NAVAL FACILITIES ENGINEERING COMMAND NAVAL STATION ATLANTIC DIVISION NAVAL WEAPONS STATION CHEATHAM ANNEX SITE 1		NORFOLK, VIRGINIA YORKTOWN, VIRGINIA	
DEPRESSION POOL WATER DISCHARGE			
DESIGNED BY WLD 12/18/08		CHECKED BY WLD 12/18/08	
DRAWN BY TPR 12/18/08		APPROVED BY WLD 12/18/08	
REVISIONS

**RE: RESPONSE TO VIRGINIA DEPARTMENT OF ENVIRONMENTAL QUALITY COMMENTS,  
DRAFT FINAL WORK PLAN – REMOVAL ACTION E - HOT SPOT REMOVAL AND POND  
RECOVERY AT SITE 1 – LANDFILL NEAR INCINERATOR CHEATHAM ANNEX, WEAPONS  
STATION (NWS) YORKTOWN. CONTRACT N62470-02-D-3260, TASK ORDER NO. 69 SHAW  
PROJECT 121382.**

**DRAFT FINAL WORK PLAN  
REMOVAL ACTION E – HOTSPOT REMOVAL AND  
POND RECOVERY AT SITE 1 – LANDFILL NEAR INCINERATOR  
CHEATHAM ANNEX, WEAPONS STATION (NWS) YORKTOWN**

FIGURE 1

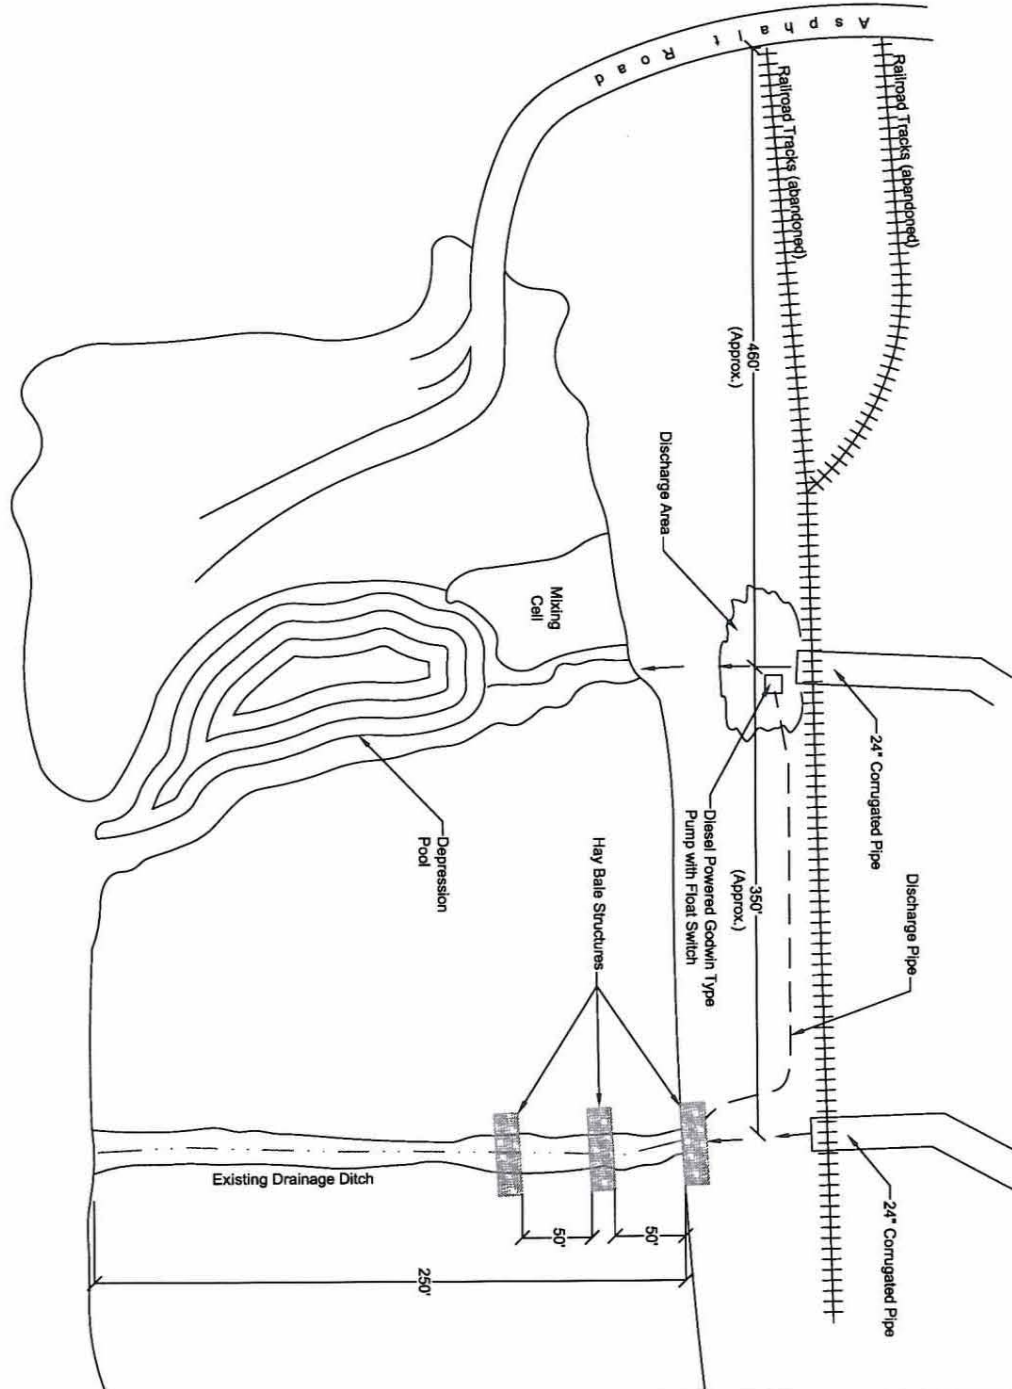
5. **(5) VDEQ:** “This section stated ‘This will allow water flowing into the site to be pumped around the area of excavation and into the river...’ this office has concerns about the perception of a point source discharge of collected storm water, flowing directly into the York River. For obvious reasons, please consider creating an infiltration gallery (at the discharge point, illustrated in Figure 4) in which conveyed storm water can be allowed to infiltrate back into the surrounding soils and/or surificially flow back into the York River, versus a hard-pipe discharge. Also, this office recommends that potential suspended solids (conveyed in the storm water) be addressed via a filter fabric or sediment trap structure.”

**RESPONSE:** Shaw will install a self priming centrifugal pump near where the railroad tracks were removed

at the top of the hill on the west side of the site. The pump will take suction in the pool created naturally by the discharge of a storm sewer pipe. The pump will discharge approximately 350 feet north through a tiered set of hay bales and into a natural drainage flow. The hay bales will filter any sediment from the water as well as act as velocity disrupters. The water will continue through the hay bales and flow uninterrupted along its natural path. This change will be reflected in the work plan.
